Bar-Ilan University Tel-Aviv metro M2 line Ramat-Gan

Assessment of NTA's Environmental Impact Survey

doc.ref.: BIU-Ramat-Gan-M2-EIS-Assessment-v02.doc
version: 0.2
date: 06-11-2020
author: Dick van Bekkum

EIS Illustration 4.4.1.5.1 - Magnetic field flux at DC of 1500 amps (common situation)

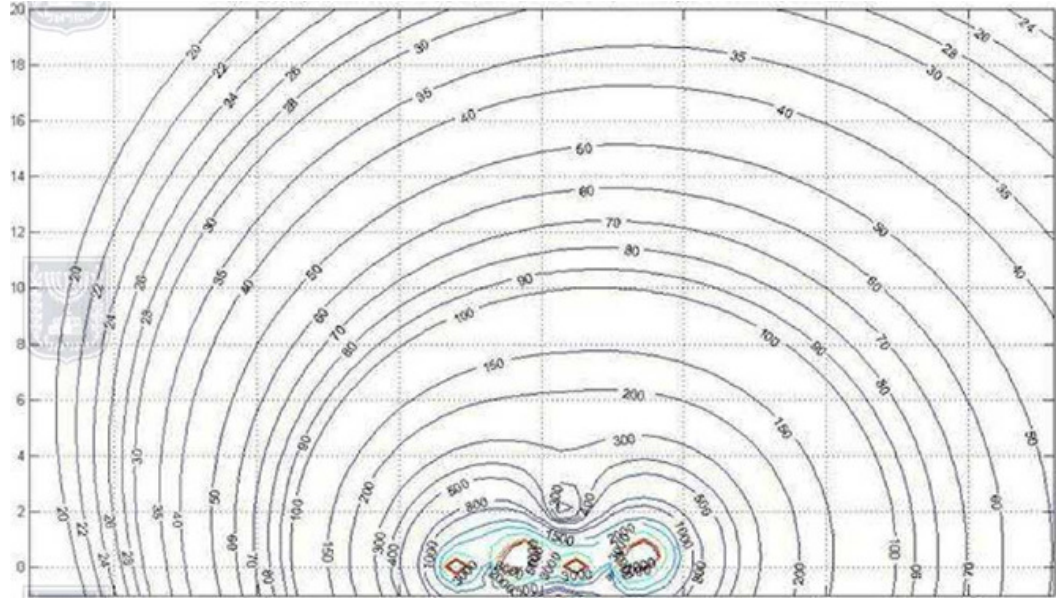
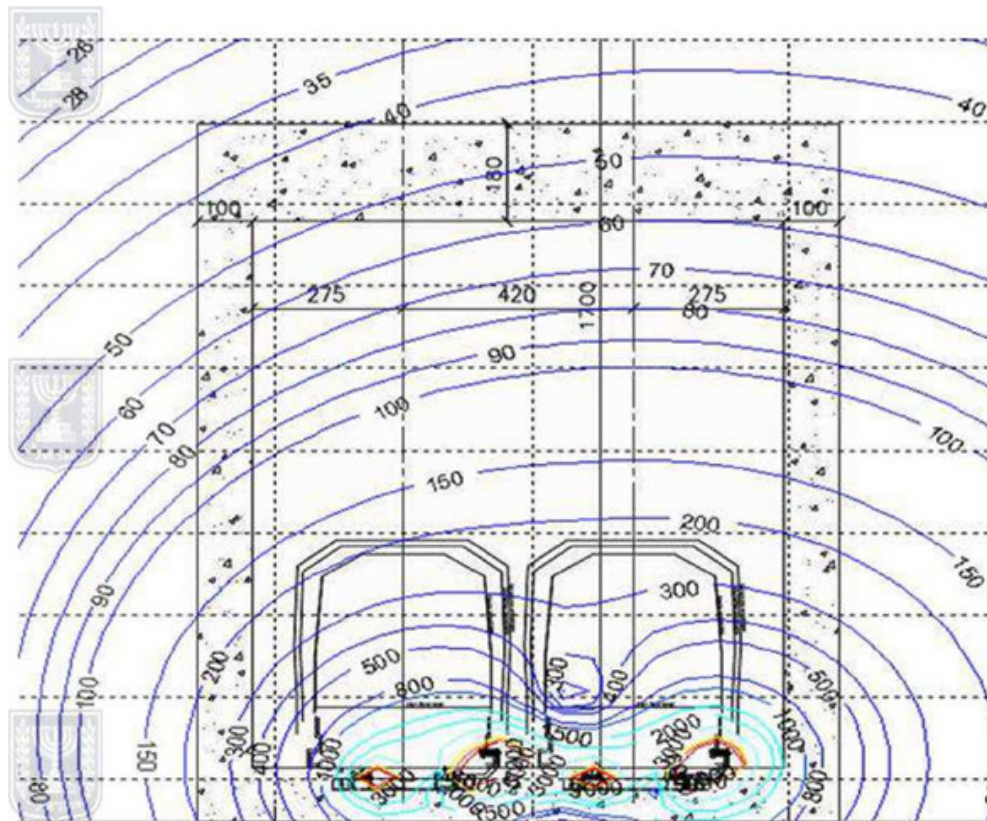
If we assume the calculations to be performed correctly, then at 1 m above ground level the static emission reaches 40 mG which is 4 μ T or 4000 nT. That is very much taken into account that the sensitivity of instruments is in the order of 10-100 nT. At best, this is a factor 40 too high. The problem is the statement that this is DC. On the average that may be true, but instruments suffer from instantaneous changes. If the average current is 1500 Amps per train, then the actual value can easily

be anything between 200 and 2800 Amps. And the rate of change (during acceleration or braking can easily be 2600 Amps in ten seconds. And that are situations which can cause unacceptably high interference.

The assumption that this is a DC emission is not at all correct. It is ELF emission.

EIS Illustration 4.4.1.5.5 - Magnetic field flux with AC (13,6 A ripple of traction rectification)

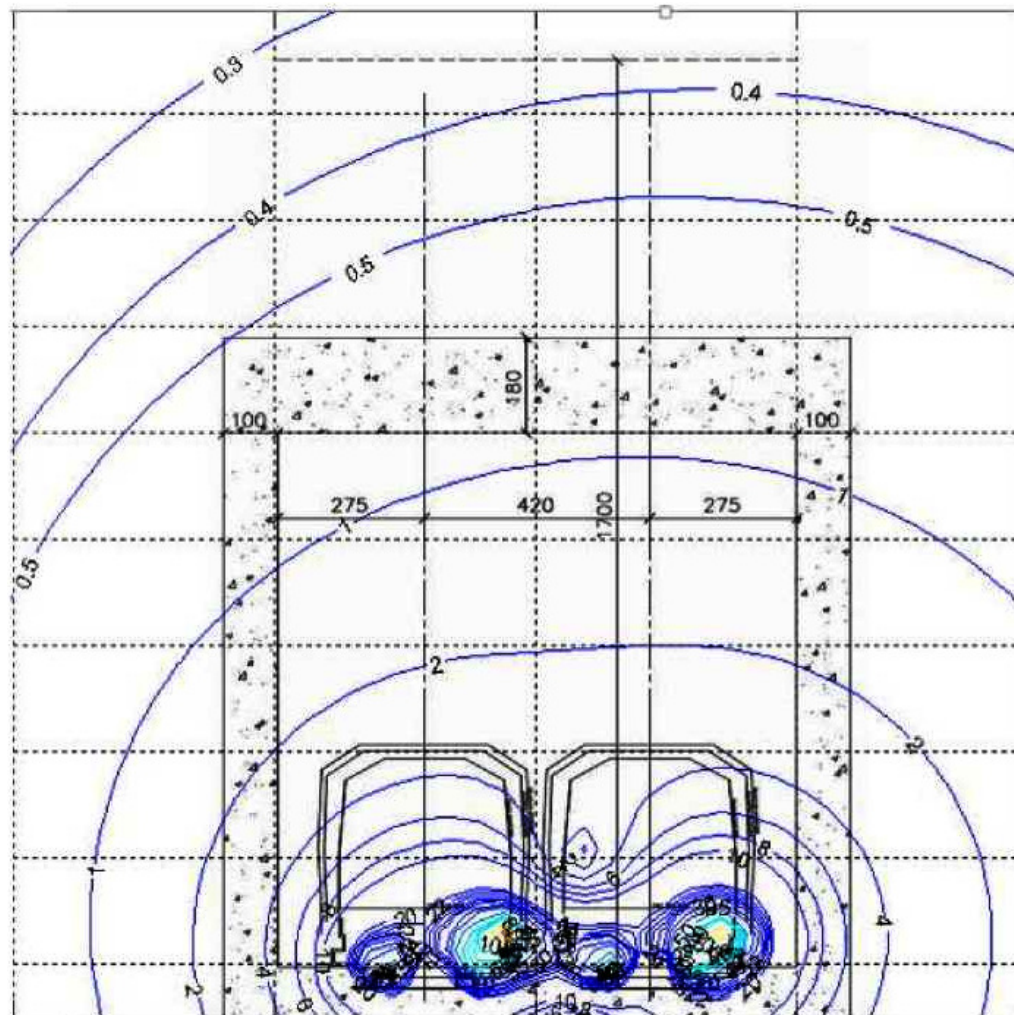
A ripple has to do with the rectification process converting a 50 Hz voltage into DC. Usually rectification uses power transformers to lower the voltage and diode bridges to rectify the AC to DC. The technology is such, that the output voltage is DC with a little AC ripple with a frequency of a multiple of 50, such as 300, 600 or even 1200 Hz. Apparently, that is the AC, meant in this chapter. However, voltages do not cause magnetic fields, but currents do. And ripple voltages do not necessarily cause ripple currents of the same frequency. The loads of traction power supply are the vehicles' systems, of which the drive systems are the ones that absorb the highest currents. But drive systems have power electronic switching converters with a complex impedance that varies over time. Thus, it is highly unlikely that the rectification ripple voltages result in current ripple with the same shape and frequency.

In any case, these kind of ripple currents are many orders of magnitude smaller than the varying DC currents, caused by variation in power demand.

It is not quite clear, how the flux density was calculated and which of the conductors (third rails and running rails) have been supposed to carry ripple currents. Therefore, it is difficult to check whether or not the calculations have been performed correctly.
